Access Compliance Report

Public Rights-of-Way

(Curb Ramps)

Intersection ID: 4041	Main Street: HEADQUARTERS_FARM_RD	Cross Street: WEDNESBURY_BV	Location: NE
ADA ID: E52CB83037FB	Ramp Type: Perp	Initial Pass/Fail: Fail	Overall Compliance: No
		Severity Score: 8.75	
Codes/Mitigation Info/Possible Solution		Field Measurements/Component Compliance

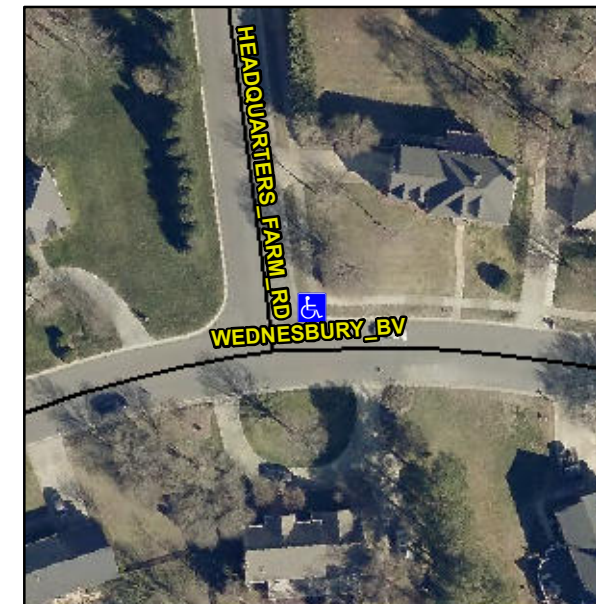
Not Found, R304.5.1

Compliance	Description	Data	Compliance	Description	Data
N/A	Ramp Length (in)	71.0	Yes	Ramp Slope (%)	5.5
No	Ramp Width (in)	36.0	Yes	Ramp XSlope (%)	1.6
N/A	Flare Type LT	N/A	N/A	Flare Type RT	N/A
N/A	Flare Slope LT (%)	N/A	N/A	Flare Slope RT (%)	N/A
N/A	Flare Traversable LT?	N/A	N/A	Flare Traversable RT?	N/A
N/A	Landing Length (in)	N/A	N/A	DWS Provided?	N/A
N/A	Landing Width (in)	N/A	N/A	DWS Contrast?	N/A
N/A	Landing Slope (%)	N/A	N/A	DWS Length (in)	N/A
N/A	Landing X Slope (%)	N/A	N/A	DWS Full Width?	N/A
N/A	Landing Curb? (Y/N)	N/A	N/A	DWS Offset (in)	N/A
N/A	Shared Landing?	N/A			
N/A	Gutter Ponding?	N/A	N/A	Gutter Slope (%)	N/A
N/A	Gutter Lip Ht (in)	N/A	N/A	Gutter X Slope (%)	N/A
N/A	Painted X Walk1?	No	N/A	Painted X Walk2?	N/A
	X Walk 1 Direction	To W		X Walk 2 Direction	N/A
N/A	X Walk 1 Width (in)	N/A	N/A	X Walk 2 Width (in)	N/A
	X Walk 1 Slope (%)	5.1		X Walk 2 Slope (%)	N/A
	X Walk 1 X Slope (%)	2.0		X Walk 2 X Slope (%)	N/A

Remove & Replace Entire Ramp.
